PUBLIC MEETING TOWN OF HUDSON, NH December 9, 2015

> D. Orchard at Nottingham (OSD) Subdivision SB# 09-15

E. Hudson Hilltop Self-Storage Expansion SP# 11 – 15

Staff Report December 9, 2015

Figure 2
2015 Existing
Peak Hour Traffic Volumes

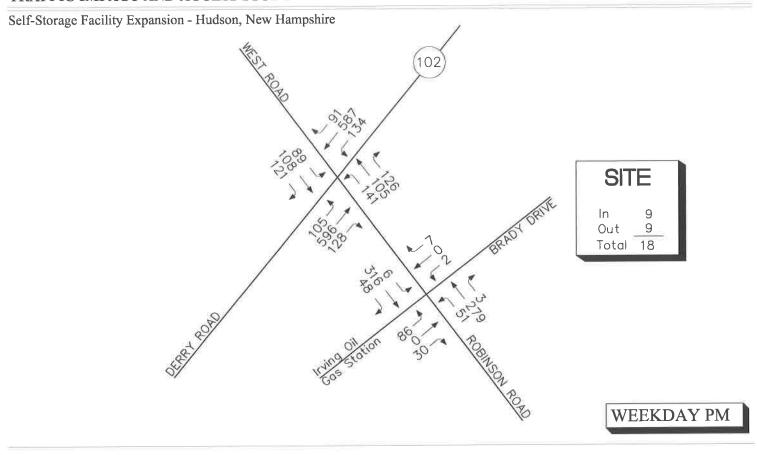
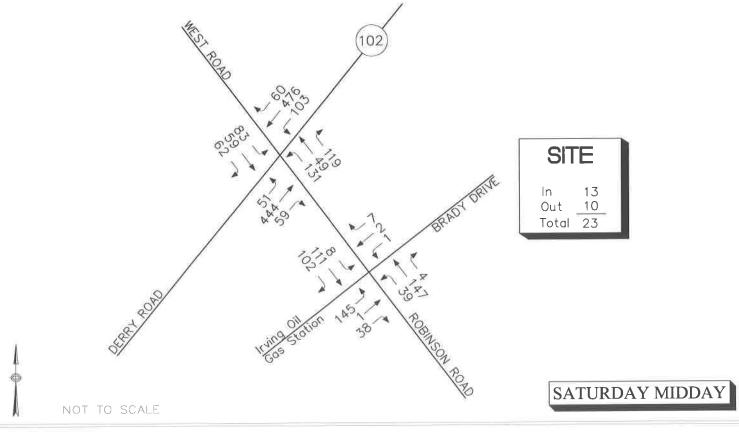
- 4) Trip Generation it is unclear where the 'counted trips' shown in the Appendix for the Saturday peak period came from, since these numbers do not agree with the volumes shown in Figure 2. It appears these numbers were derived from applying the per-unit rate from the 315 units to the 96 units from 2013, but this was not calculated the same way for the weekday PM peak case. While the approach appears reasonable, the calculations are confusing.
